**Re: Defect Information Report – Supplemental Report No.02
08V-668, FL-542, MBE 900 EPA04 High Pressure Fuel Lines**

Subject: **Safety Recall 08C3**
MBE 900 EPA04 High Pressure Fuel Lines

SUBJECT: HIGH PRESSURE FUEL LINES AND TRANSFER TUBES

Figure 1 High Pressure Fuel Line

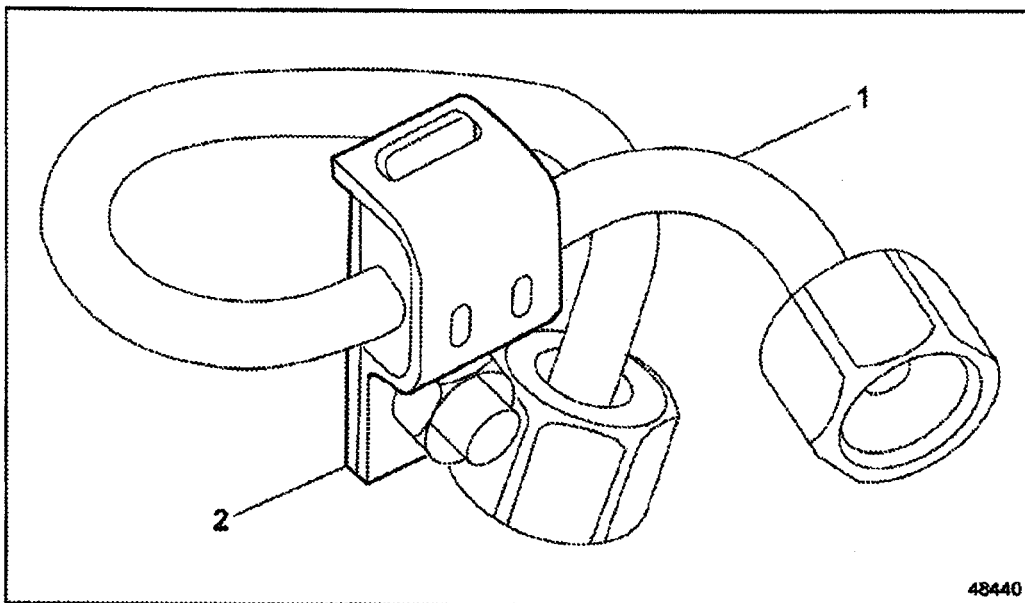
2. Remove the engine lifting bracket to improve access to the fuel lines.
 - [a] Remove the left front lifting bracket by removing the three bolts securing the bracket to the cylinder head.
 - [b] If the application has a high mount fan, remove the three secondary mount bracket retention bolts on the cylinder head and the two bolts on the high mount fan bracket.
3. To prevent the transfer tube from rotating during the high pressure fuel line disassembly, secure the transfer tube thrust nut using a 24 mm fuel line wrench (J-47484 or J-45063) and loosen the high pressure fuel line nut at the transfer tube using a 17 mm fuel line wrench (J-47483) or a 17 mm open end wrench. See Figure 1.

4. Using a 17 mm fuel line wrench (J-47483) or a 17 mm open end wrench, loosen the high pressure fuel injector line nut at the electronic unit pump. Discard the high pressure fuel injector line.
 5. Using a 24 mm fuel line wrench (J-45063 or J-47484) or a 24 mm socket, loosen the thrust nut on the transfer tube. Remove and discard the transfer tube and the O-ring. See Figure 1.
-

Figure 2 Damper Clamp Alignment

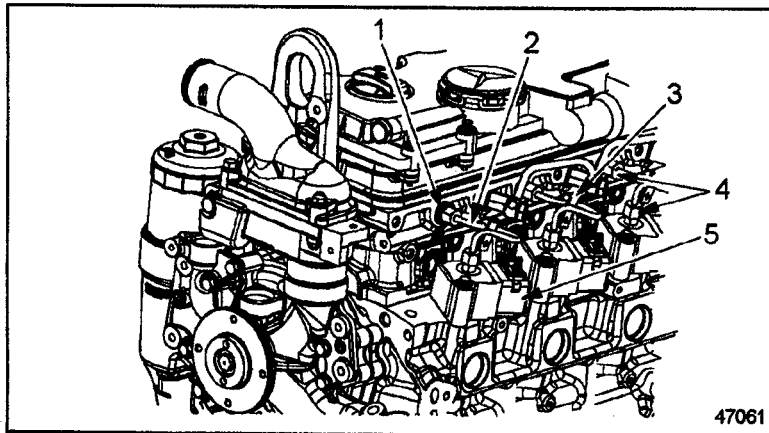
1. The new high pressure fuel line comes assembled with the damper clamp. Ensure that the damper clamp is aligned correctly on the high pressure fuel line and is not in contact with surrounding engine components. See Figure 2.

Figure 3 High Pressure Fuel Line

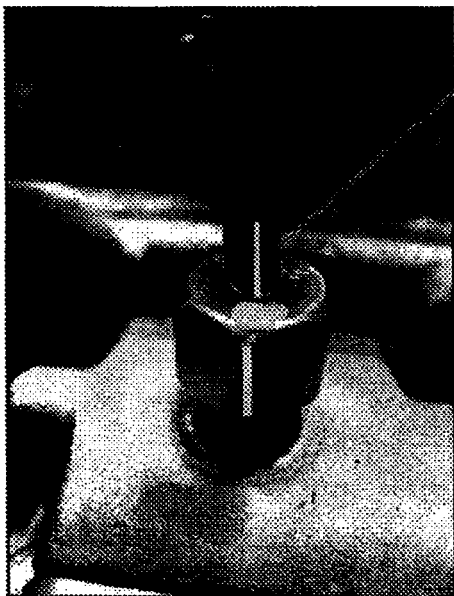
5. Hand-tighten the high pressure fuel injector line nut first at the unit pump, and then at the transfer tube. While hand tightening the nuts, gently move the high pressure fuel line back and forth to ensure the end of the line is properly seated in the transfer tube and unit pump fitting. If the high pressure fuel injector line has been installed incorrectly and torqued, remove the high pressure fuel injector line and transfer tube and replace with new parts. Ensure that the damper clamp is not touching any other fuel lines or other engine or vehicle components. See Figure 3.

Figure 4 Marking of High Pressure Fuel Injector Line and Nuts

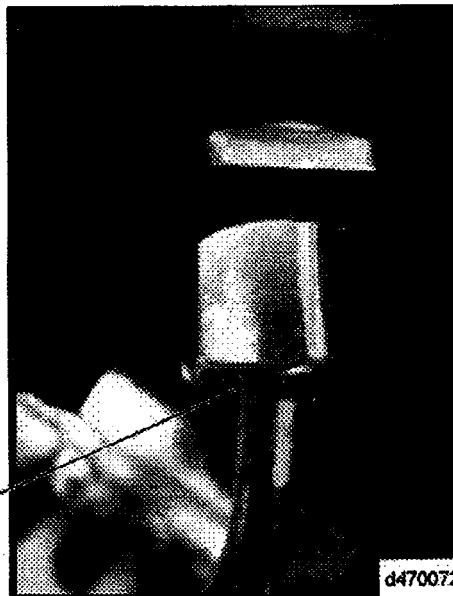
6. Once the high pressure fuel injector line nuts are hand tight, draw a vertical line with a highly visible marker along the front edge of both of the nuts and up the fuel line. The line drawn along the edge of the nuts and the fuel line should be aligned. See Figure 4.
